**MARIN COUNTY PLANNING DIVISION
MINISTERIAL DECISION**
Hoyt, Lee Housing Compliance Review

Decision: December 6, 2024
Date: Approved with conditions

Project ID No:	P4478	Applicant(s):	Marinwood Propco LP
		Owner(s):	Lee Hoyt
		Assessor's Parcel No(s):	164-64, -65, -69 and -70
		Property Address:	121, 155, 175 and 197 Marinwood Avenue, San Rafael (Lucas Valley)
		Project Planner:	Michelle Levenson; 415- 473-3615; and michelle.levenson@ marincounty.gov
		Signature:	<i>Michelle Levenson</i>
Countywide Plan Designation:		GC-HOD (General, Commercial-Housing Overlay Combining District)	
Zoning District:		CP-HOD (Commercial, Planned-Housing Overlay Combining District)

Drawing No. **F10**

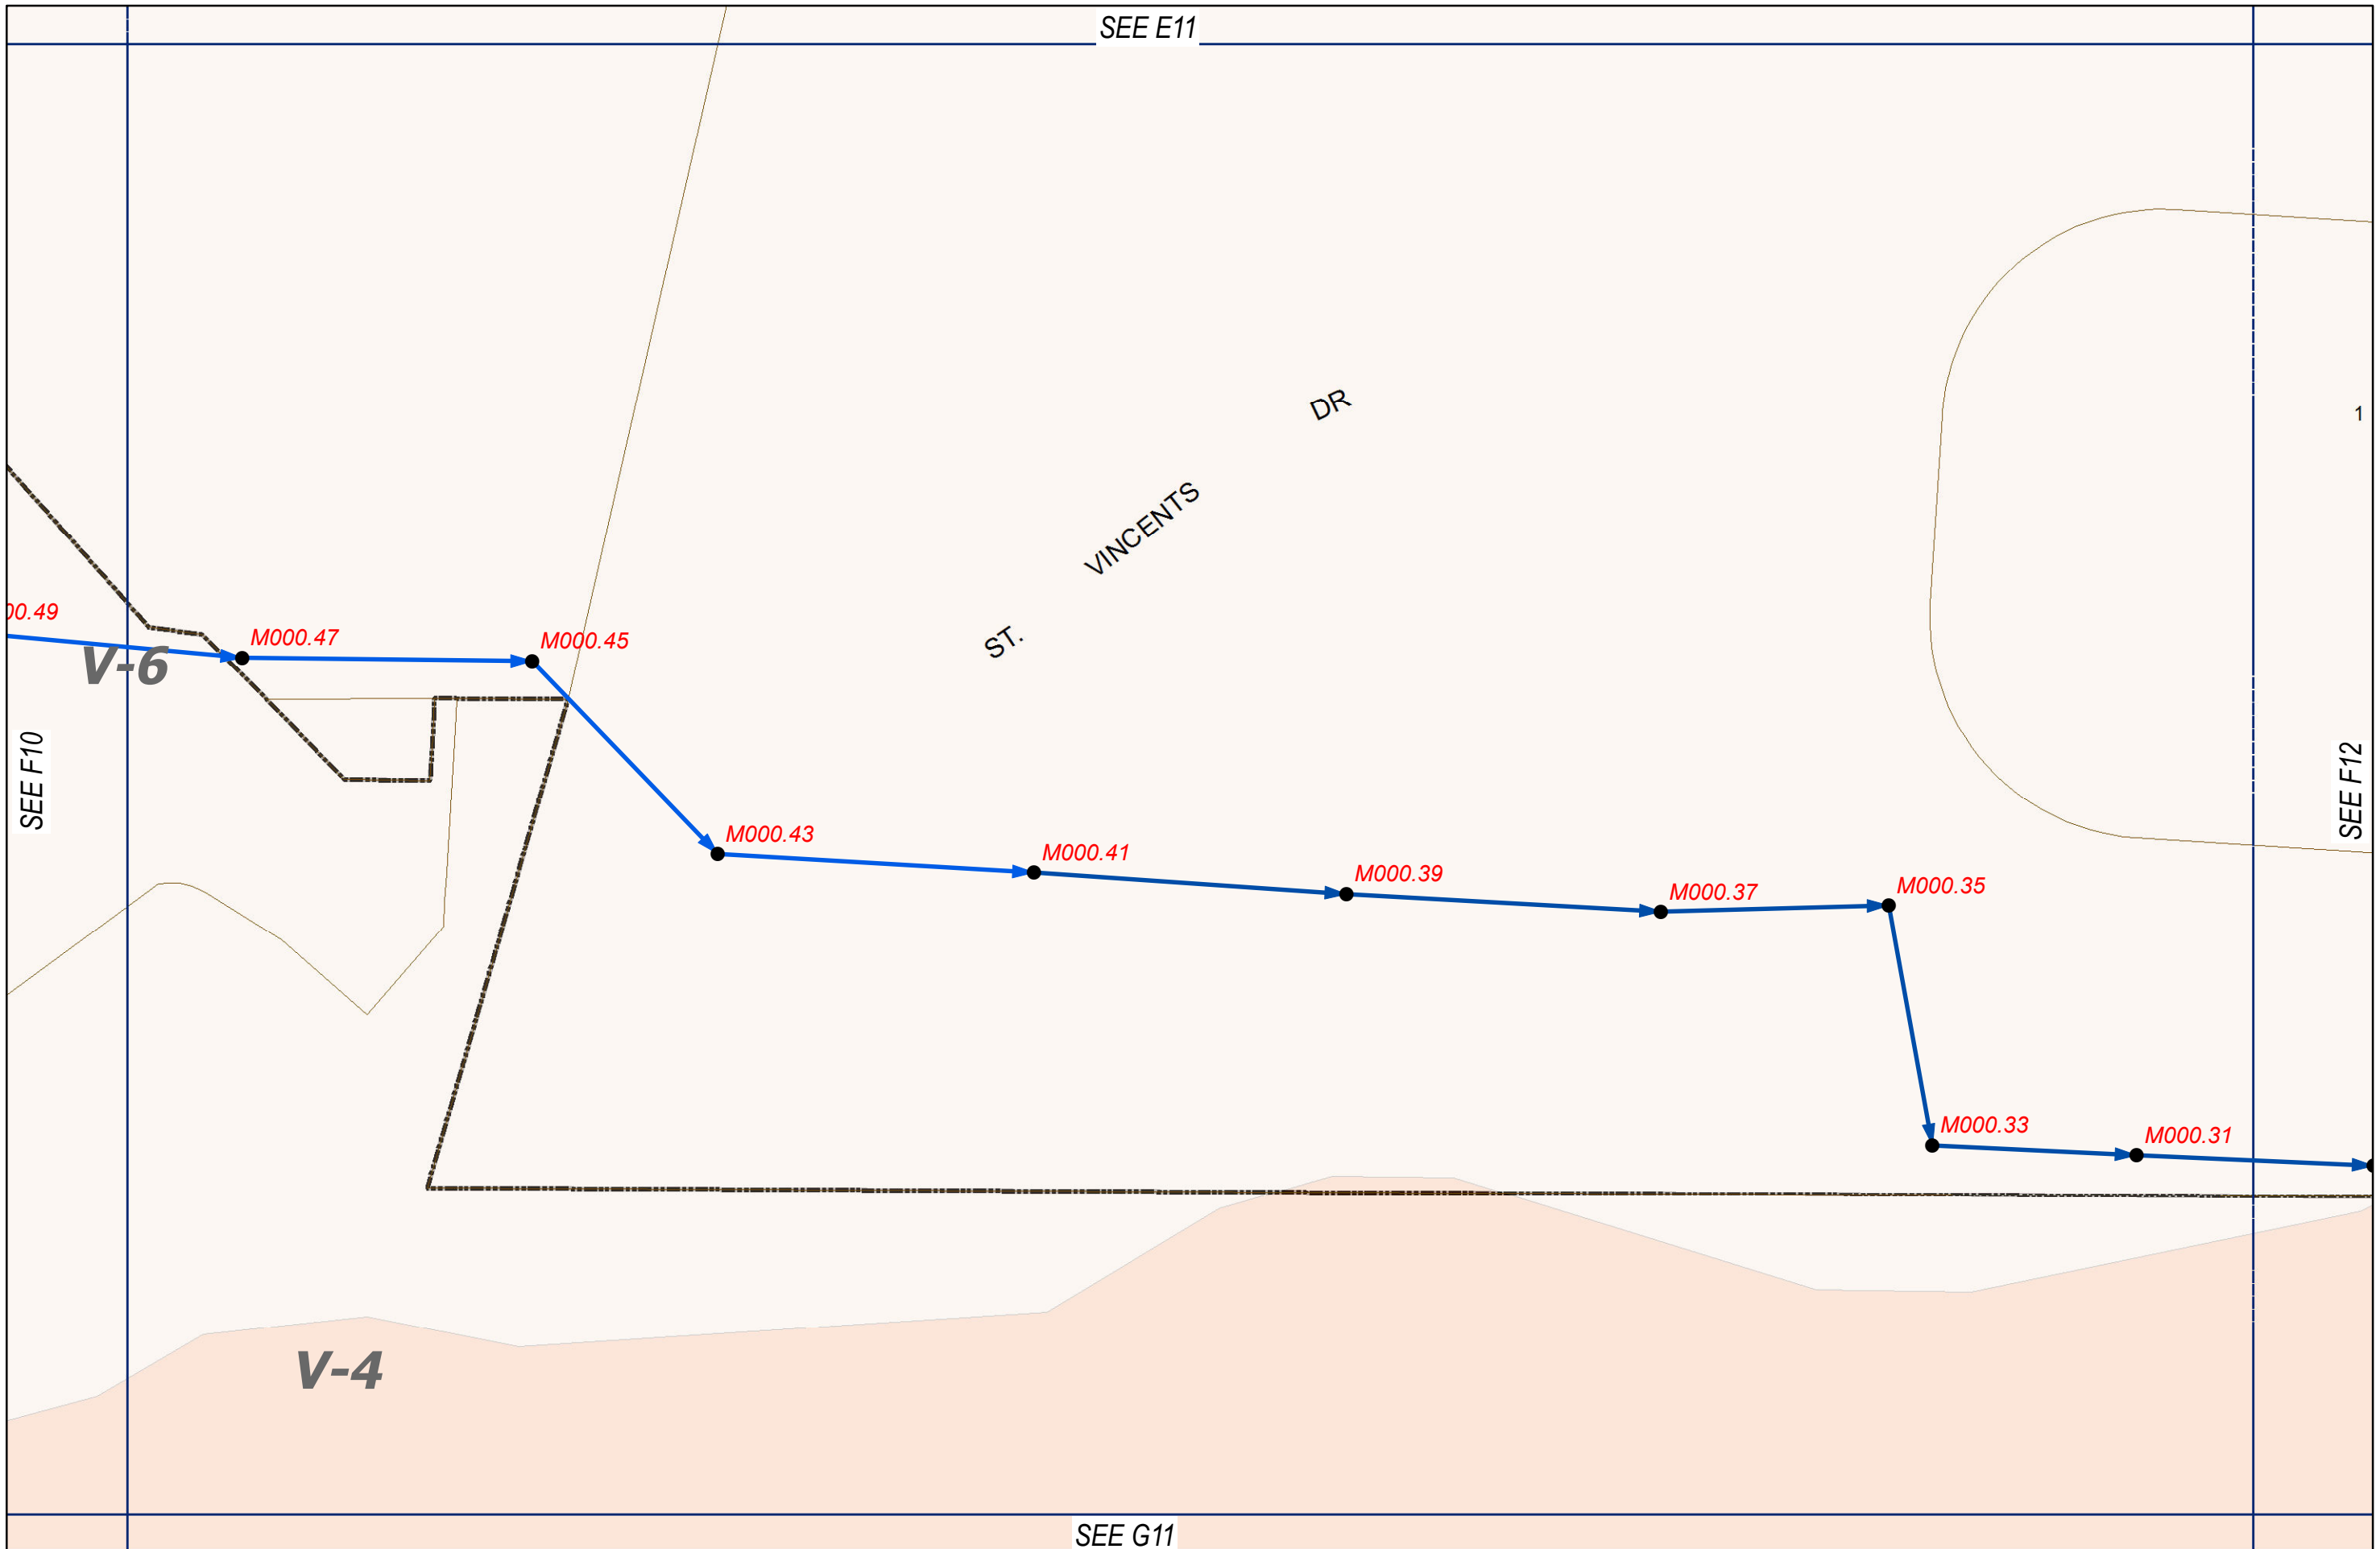
- i. See attached Exhibit A for basin maps for a segment of Marinwood Trunk Sewer likely to be impacted by the proposed development. The segment begins from MH M017.12 on Map F10 to MH M000.01 (terminal manhole near Marinwood Pump Station at the treatment plant) on Map H12.
